# MARCO POLO - 101 W 33RD STREET

Date	Description
05.19.2022	Progress Set

6A A400 BUILDING SECTION - THRU SMALL STUDIO - LOOKING EAST - @ PARAPET WALL 3/4" = 1'-0"

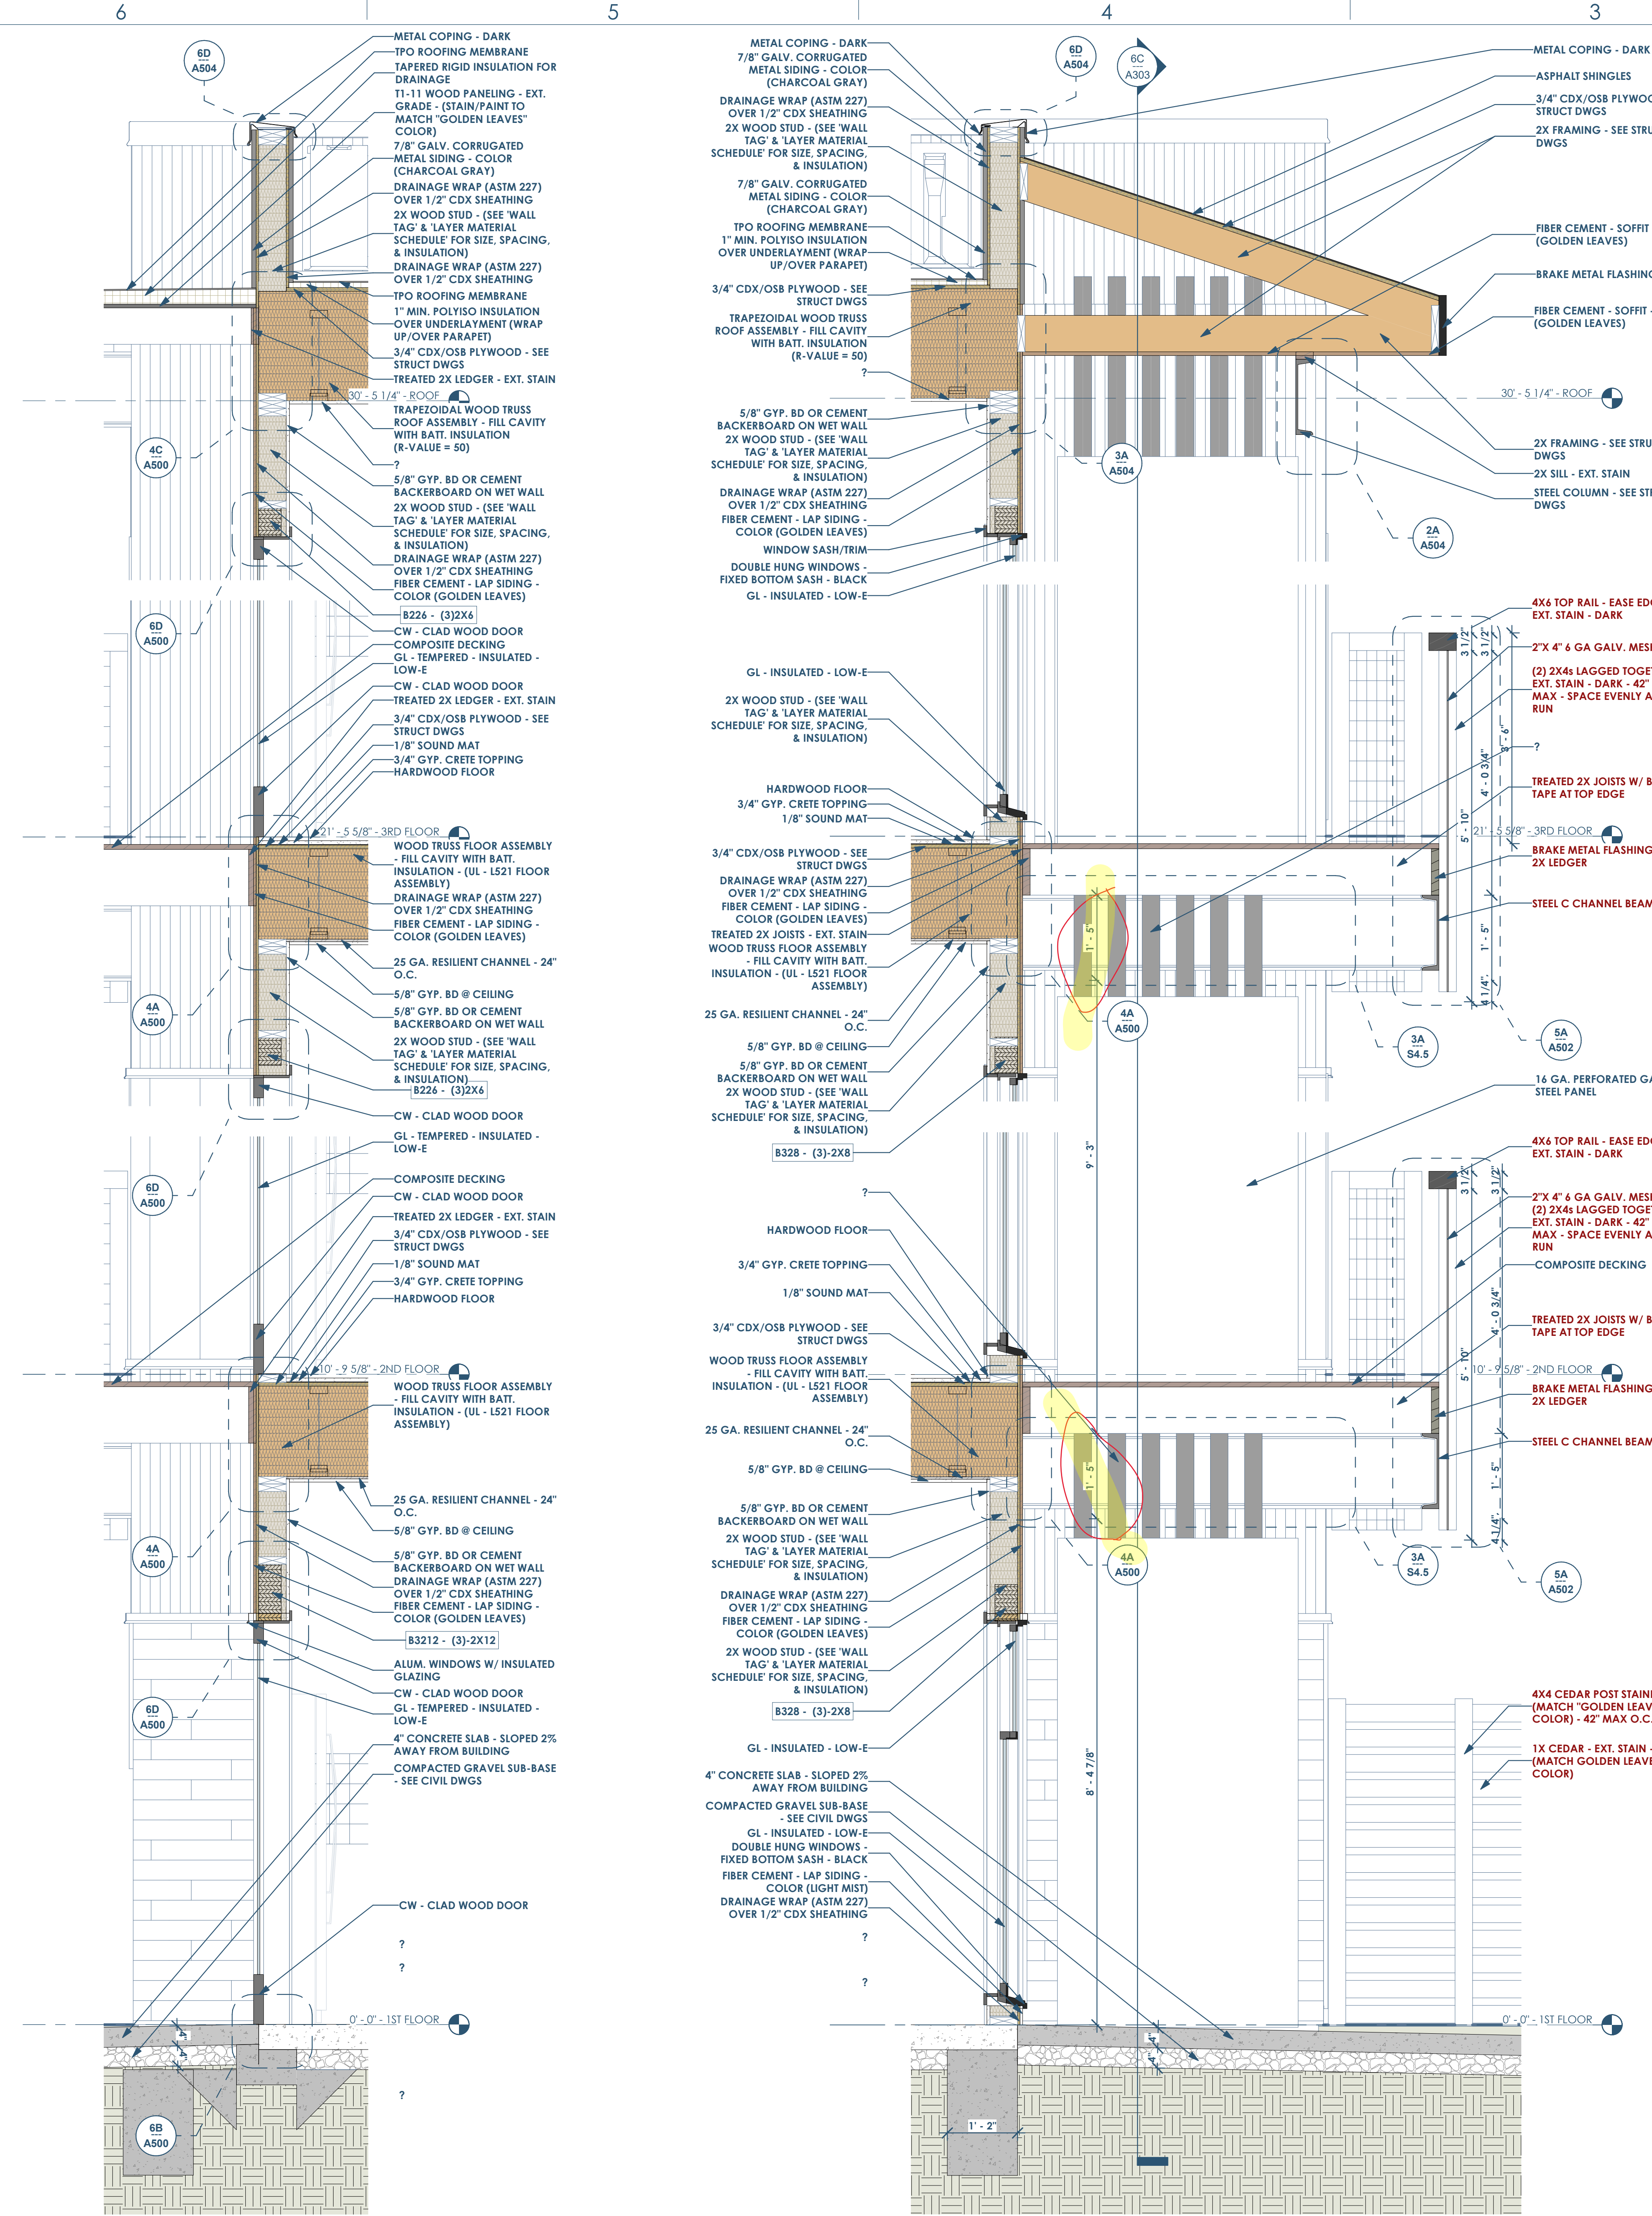
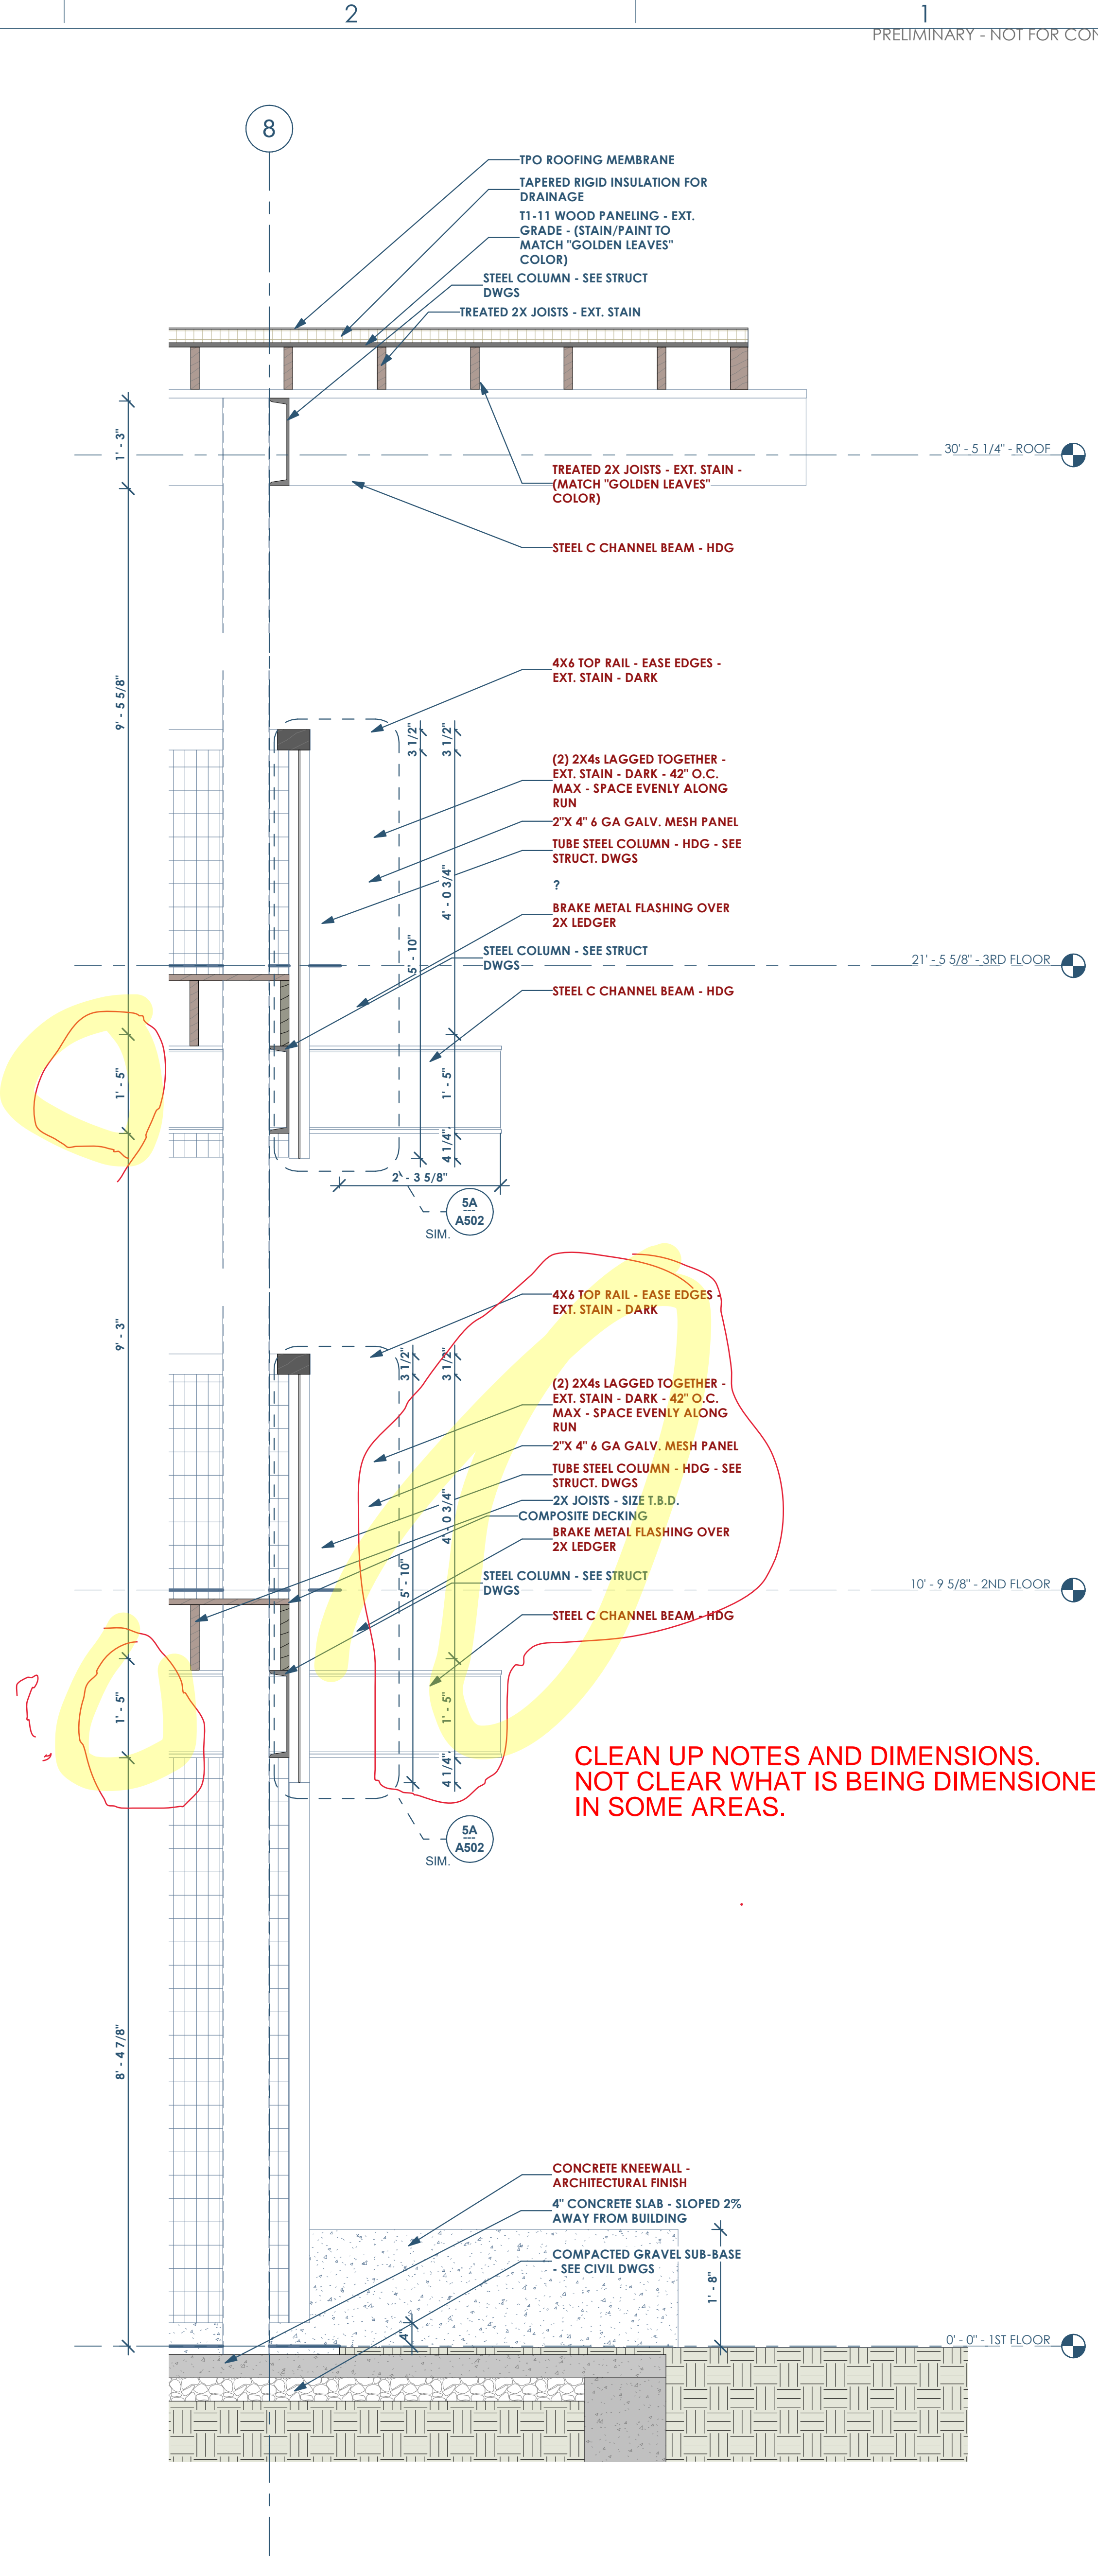
CLEAN UP NOTES AND DIMENSIONS. NOT CLEAR WHAT IS BEING DIMENSIONED IN SOME AREAS.
